MONTGOMERY COUNTY PLANNING DEPARTMENT
THE MARYLAND-NATIONAL CAPITAL PARK AND PLANNING COMMISSION

REVIEW TYPE: Preliminary Plan of Subdivision

PROJECT NAME: Barnard Property

CASE #: 119970400

PRELIMINARY PLAN
BARNARD PROPERTY
 Montgomery County, Maryland

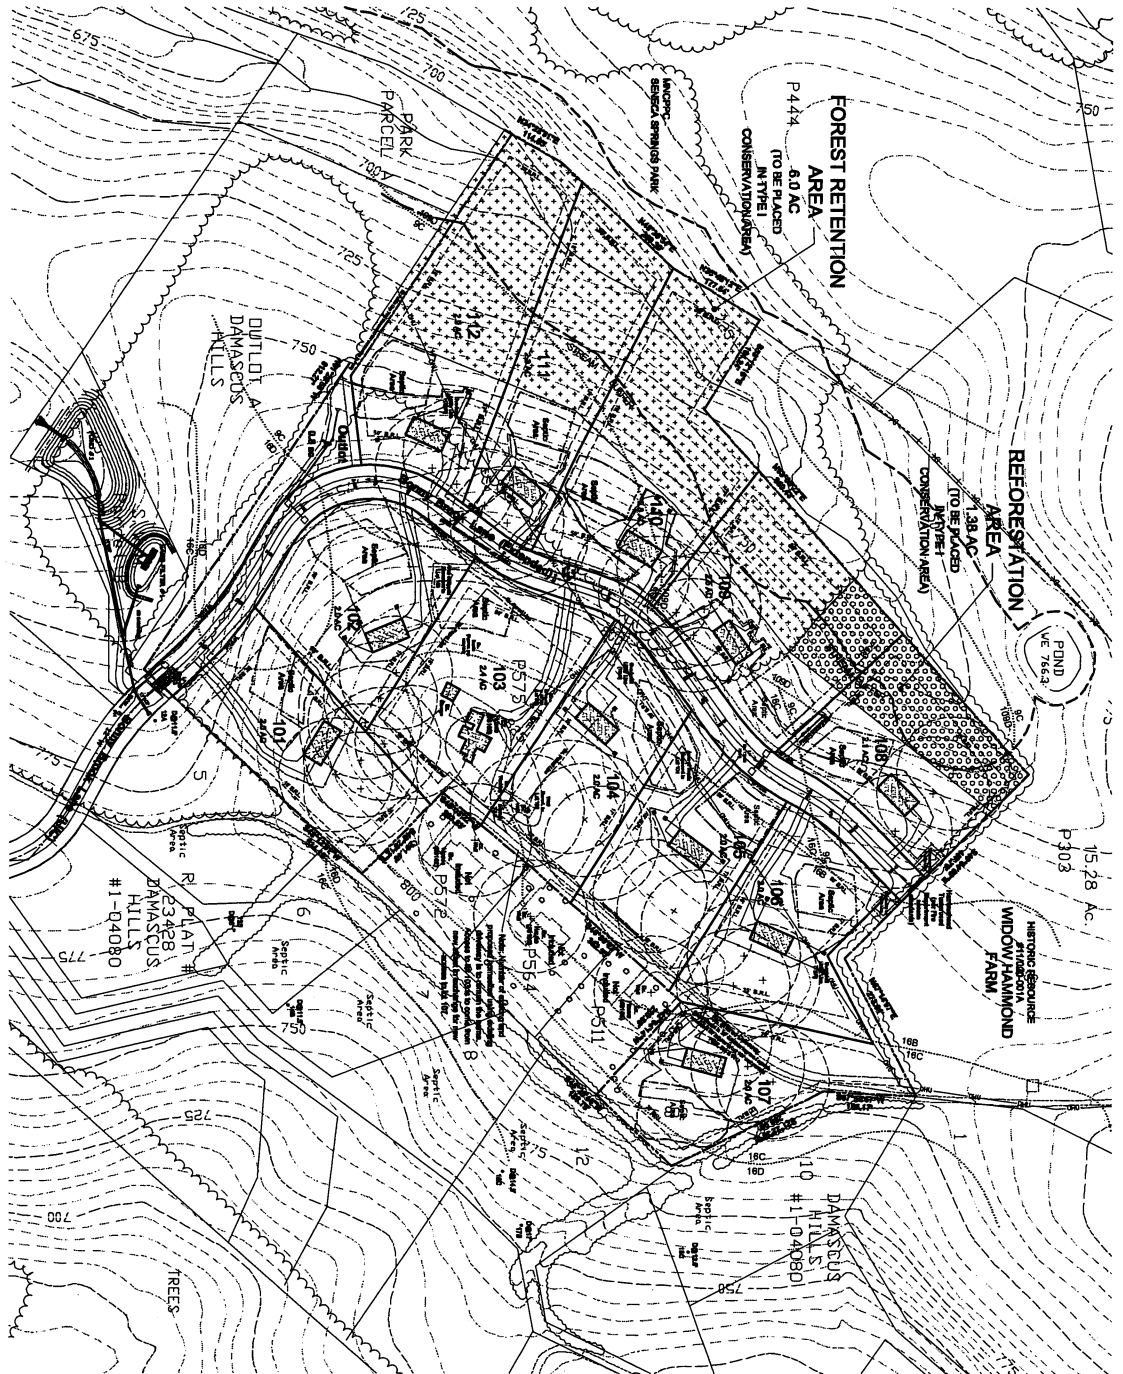
We have completed our review of the revised preliminary plan dated December 10, 2008. This preliminary plan was originally reviewed by the Development Review Committee at its meeting on October 1, 2007. We recommend approval of the plan subject to the following comments:

1. Right of way dedication and construction of Bonny Brook Lane extension as per secondary residential roadway standards (MC-211.02) ending in a standard T-turnaround (MC-223.02). We have reviewed and approved a modified flat bottom ditch that will provide stormwater management as shown on the above preliminary plan (this section should comply with applicable standards of the Maryland Department of the Environment and/or Montgomery County Department of Permitting Services).

2. Grant necessary slope and drainage easements. Slope easements are to be determined by study or set at the building restriction line.
3. Prior to approval of the record plat by the Department of Permitting Services (DPS), the applicant's consultant will need to obtain the approval of grade establishment for the proposed extension of Bonny Brook Lane.
4. Size storm drain easement(s) prior to record plat. No fences will be allowed within the storm drain easement(s) without a revocable permit from the Department of Permitting Services and a recorded Maintenance and Liability Agreement.

5. Wells and septic systems cannot be located within the right of way nor slope or drainage easements.
6. Record plat to reflect a reciprocal ingress, egress, and public utilities easement to serve the lots accessed by each common driveway.

7. Private common driveways and private streets shall be determined through the subdivision process as part of the Planning Board's approval of a preliminary plan. The composition, typical section, horizontal alignment, profile, and drainage characteristics of private common driveways and private streets, beyond the public right-of-way, shall be approved by the Planning Board during their review of the preliminary plan. Also homeowners' documents to establish each driveway user's (property owner's) rights & responsibilities with respect to use, maintenance, & liability of the common driveway.
